Development Team Review Comments

Project Number: RCU2023-00033

Project Name: Menjivar Delgado Truck Storage

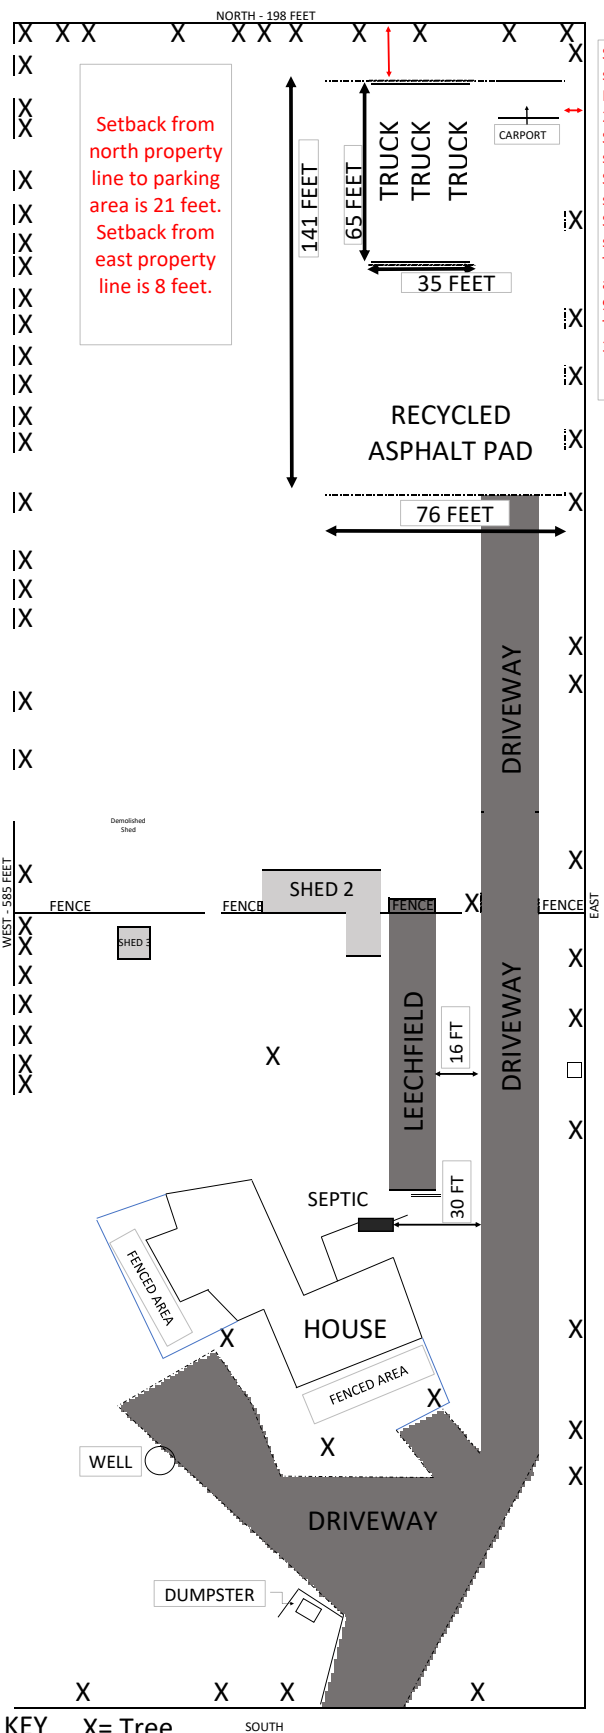
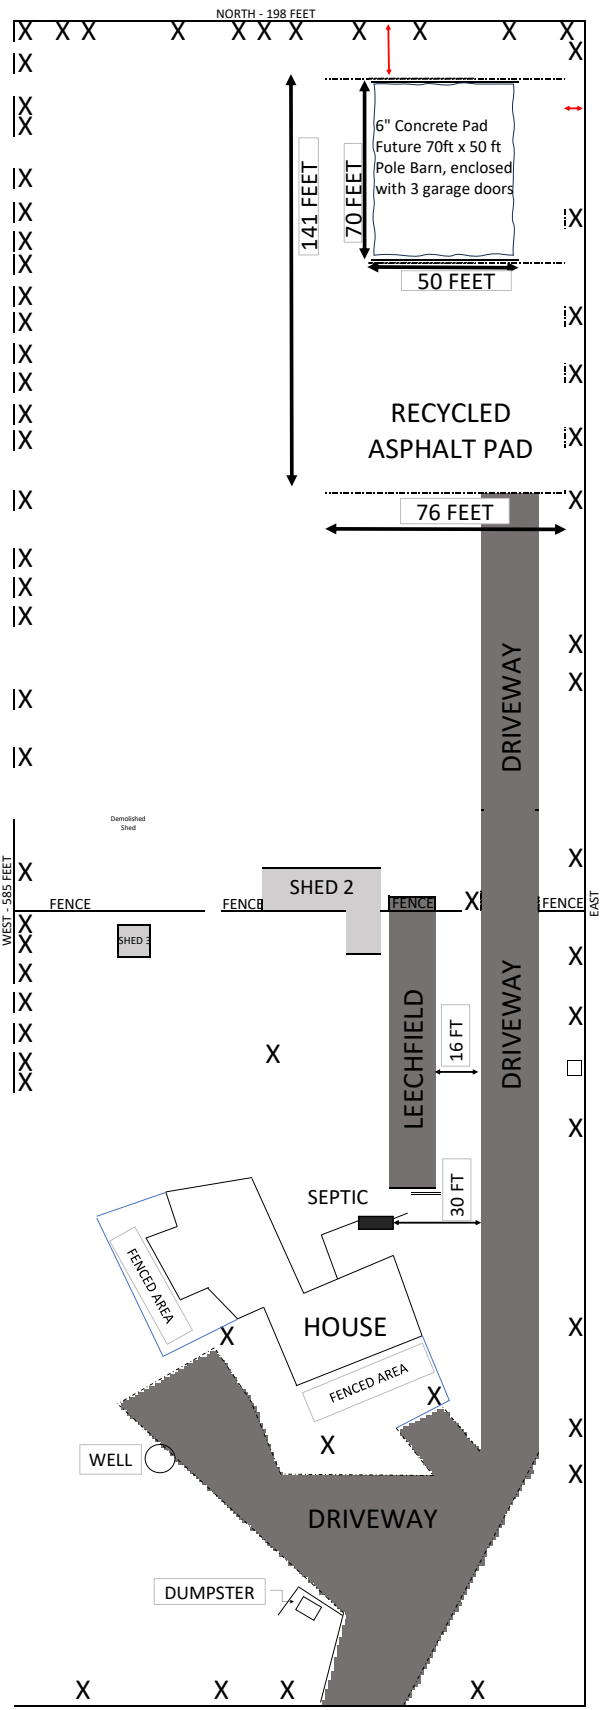
ROW1: The Site Plan is missing information:

- a. All structures must be shown and labeled. There are 5 or 6 structures on the property including house, barns and sheds.
- b. The location of the parking area delineated on the site plan
- c. The offset to the leach field and the limits of the leach field (length and width)
- d. Access to the parking area

Sq ft for structures:
House:
2223 sq ft
Shed 1: 400 sq ft
Shed 2: 780 sq ft
Shed 3: 100 sq ft
Total allotted: 9147 sq ft
Total used: 3503 sq ft
